1638C AND 1639D TELEPHONE SETS

1.001 This addendum supplements Section 502-611-404, Issue 1.

Fig. 1—1638C (MD) and 1639D (MD) Telephone Set, Connections

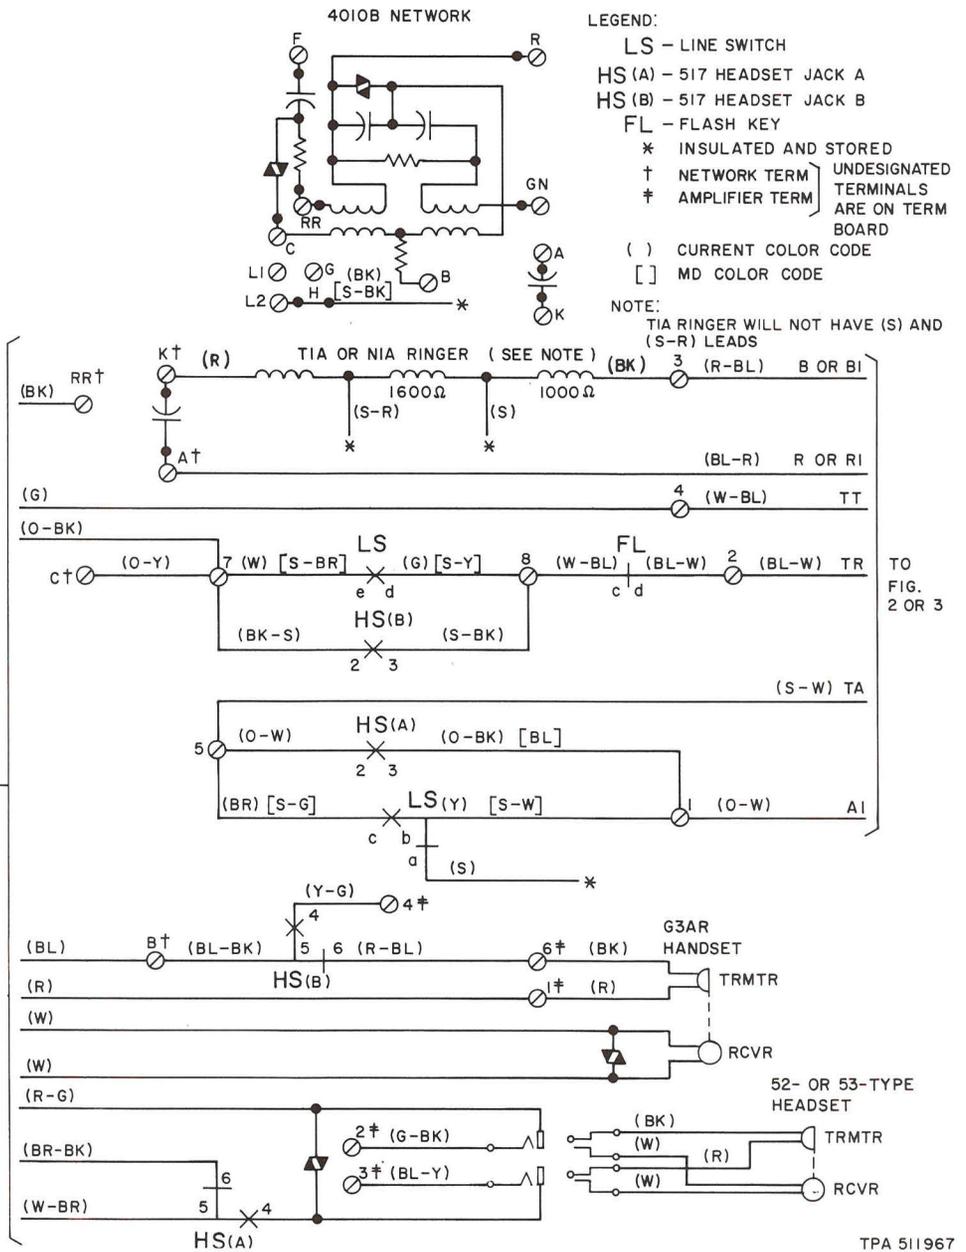
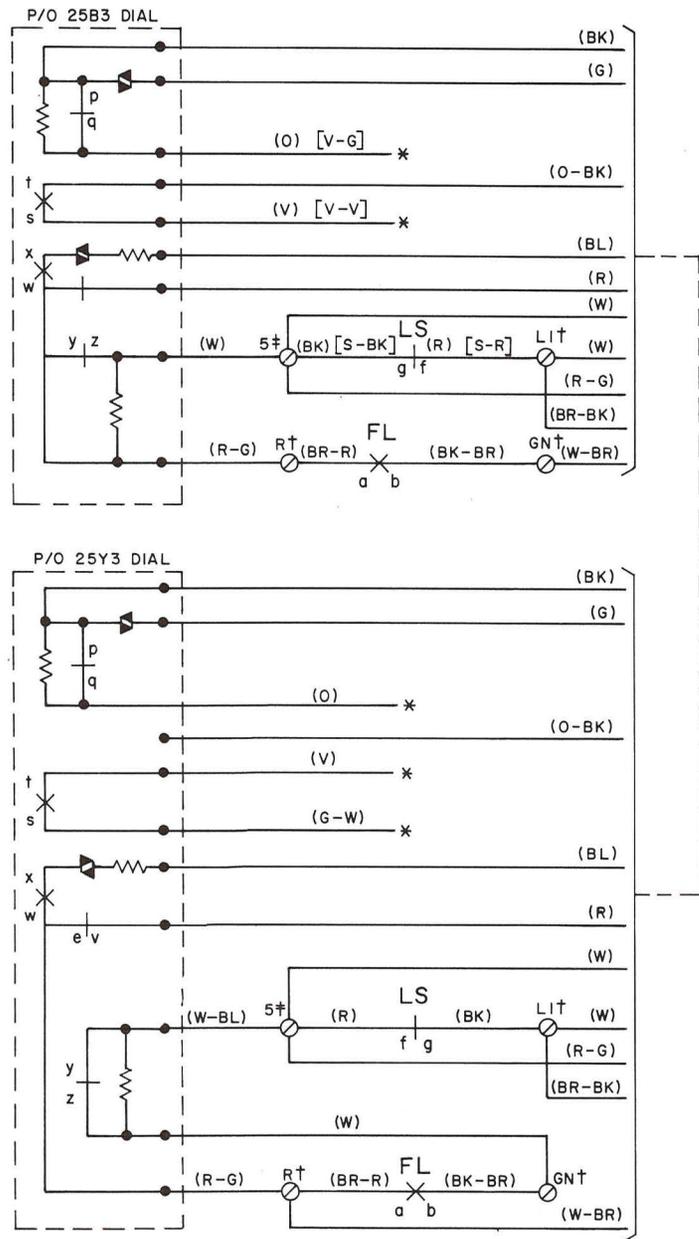
- Change Section Title
- Show 1638C and 1639D telephone sets MD.
- Revise polarity guard connections (Table A)
- Add 241B amplifier and T1A ringer

- (a) 2.08—Added
- (b) Table A—Revised
- (c) Fig. 1—Revised

2.08 1638C and 1639D telephone sets may be equipped with 241A (MD) or 241B amplifier. Connections for both amplifiers are the same.
